CITY OF ST. AUGUSTINE CORRIDOR REVIEW COMMITTEE
A G E N D A
THURSDAY, MARCH 3, 2022 - 2:00 PM
ALCAZAR ROOM - 75 KING STREET

DSEC HP2022-0007
24 & 26 Palmetto Avenue
March 3, 2022

**CITY OF ST. AUGUSTINE CORRIDOR REVIEW COMMITTEE
 STAFF REPORT AND RECOMMENDATION**
 Prepared for March 3, 2022 Meeting

① SOUTH ELEVATION - BLDG 2 (BUSAM STREET)
 A5.4 | A5.4 SCALE: 1/4" = 1'-0"

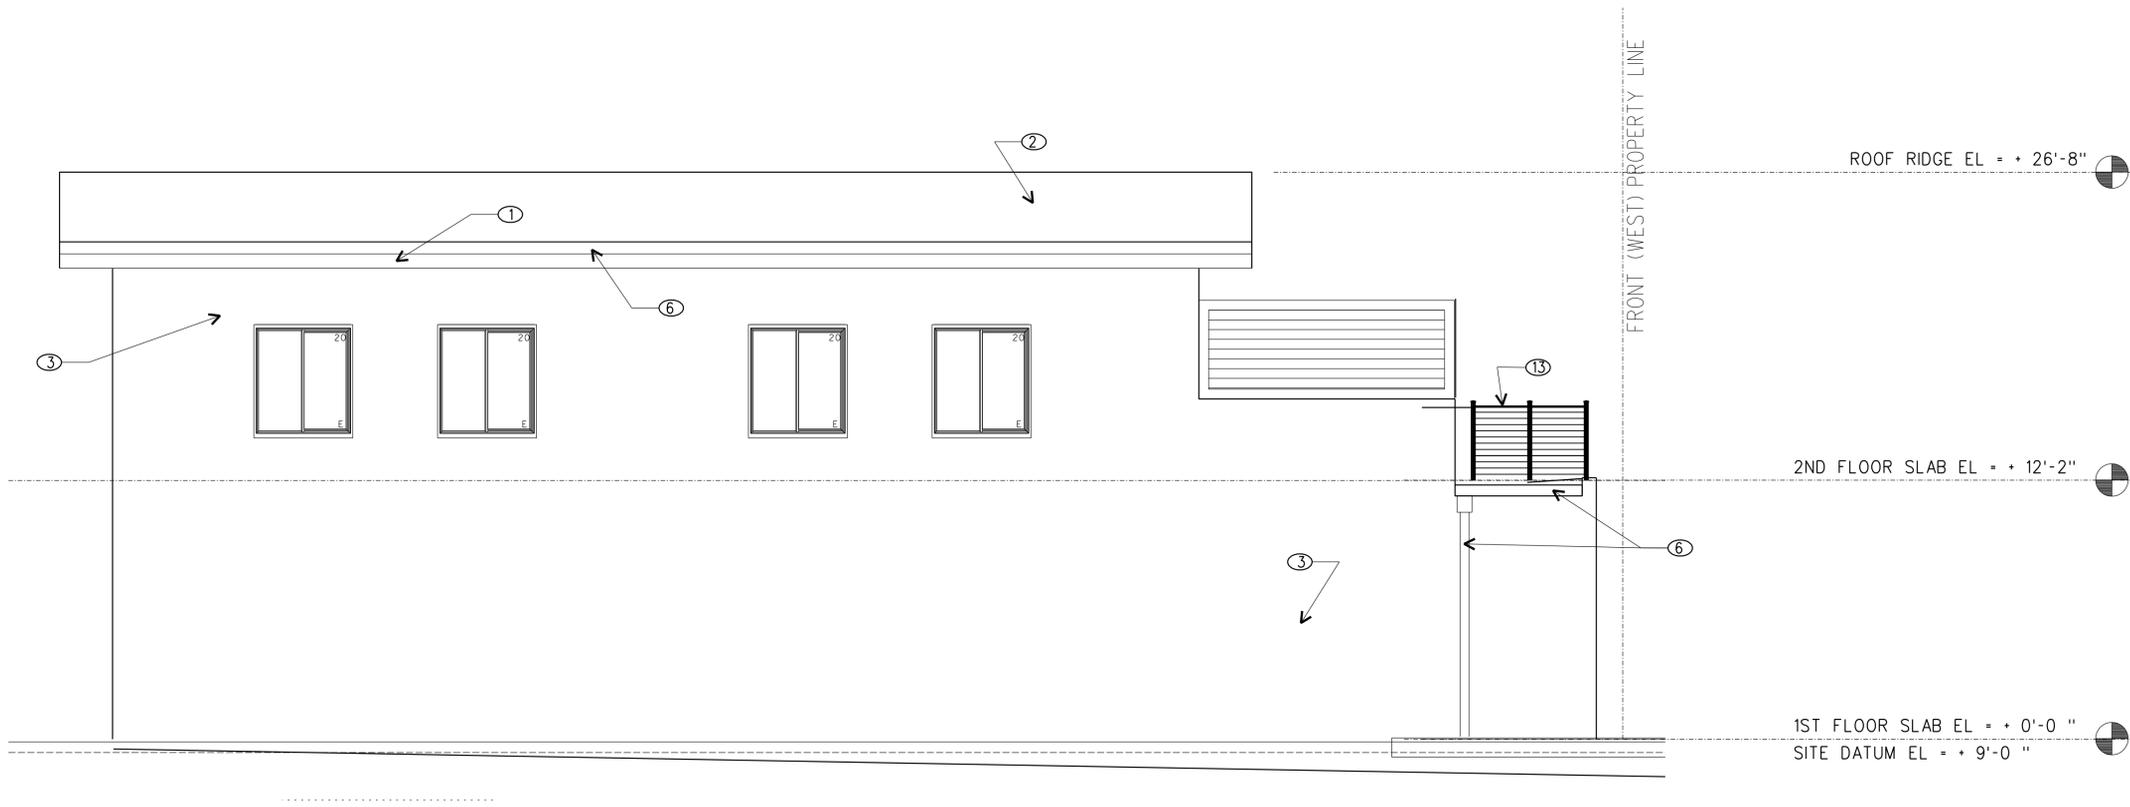
In the final plan submittal received February 22, 2022, the applicant indicated a glazing modification request for the south elevation glazing along Busam Street. The ground floor modification requested is within 10% of the required minimum and is staff-approvable if deemed appropriate; however, the second-floor modification request is less than the minimum threshold that the CRC could approve. The applicant could take the following actions for approval of this element of the design:

6. Glazing along Anastasia Boulevard is within required parameters. Along Busam Street, the ground floor requires a modification within the parameters to be approved by staff; however, as proposed, the second-story glazing percentage would require a variance application and approval from the PZB because it is less than the 30% modification threshold required for CRC approval. The applicant may agree to alter the design of this elevation to meet the glazing minimum that the CRC could approve as detailed above.

7. Proposed awnings are of appropriate design and material for the Corridor.
8. The Standards require the main entrance to all buildings be oriented toward Anastasia Boulevard. There is a single entry on the east end of the south façade of building 2, with other proposed commercial units accessed from the central courtyard reached from both Anastasia Boulevard or the rear parking area. The CRC should consider requesting that the design meet the Standards more fully; or, approve a modification if the applicant can provide clear justification for the proposed design.

- Redesign the second-story windows to reach the minimum required square footage for CRC approval (44.8sf of glazing); or,
- Apply to the Planning and Zoning Board (PZB) for a Variance to approve the proposed 39sf of glazing.
